Docket Number:	19-SPPE-02
Project Title:	Walsh Data Center
TN #:	232749
Document Title:	Sarvey energy Resources Reply Testimony
Description:	Sarvey Reply testimony Utilities and Service Systems
Filer:	Robert Sarvey
Organization:	Robert Sarvey
Submitter Role:	Public
Submission Date:	4/15/2020 3:04:40 PM
Docketed Date:	4/15/2020

Walsh Data Center

Robert Sarvey's Utilities and Service Systems Reply Testimony

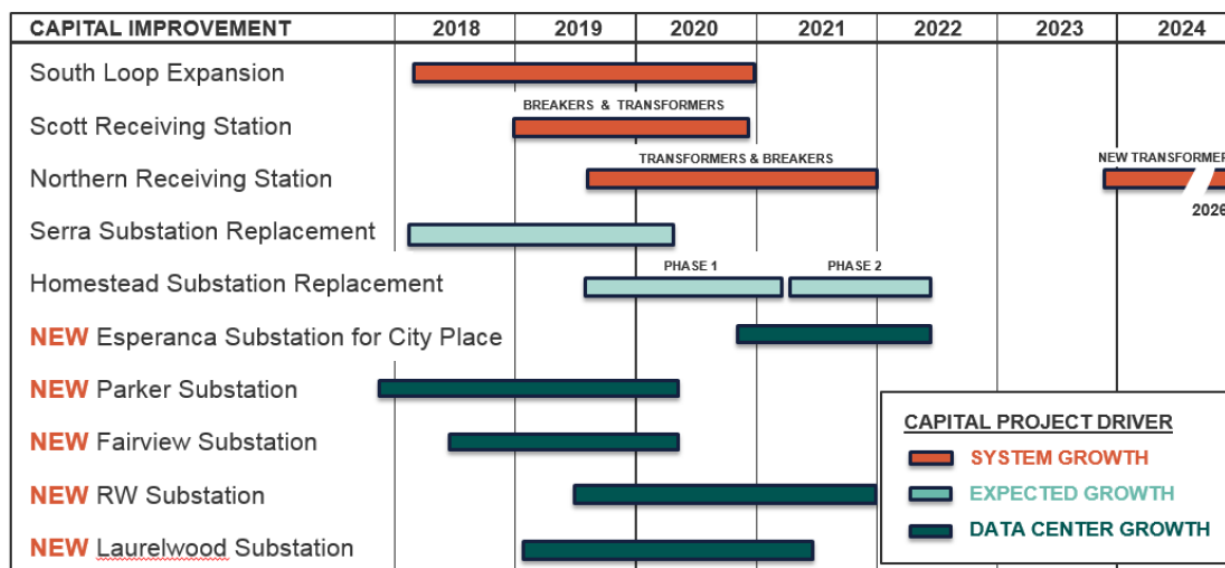
The SVP 2018 Integrated Resource Planning document provides the following chart detailing the extensive upgrades needed to accommodate data center load.

The IS/MND assertion that, “Construction and operation of the project would not require new or expanded electric power utilities” is clearly erroneous. Data Center additions will require extensive upgrades to SVP’s system.
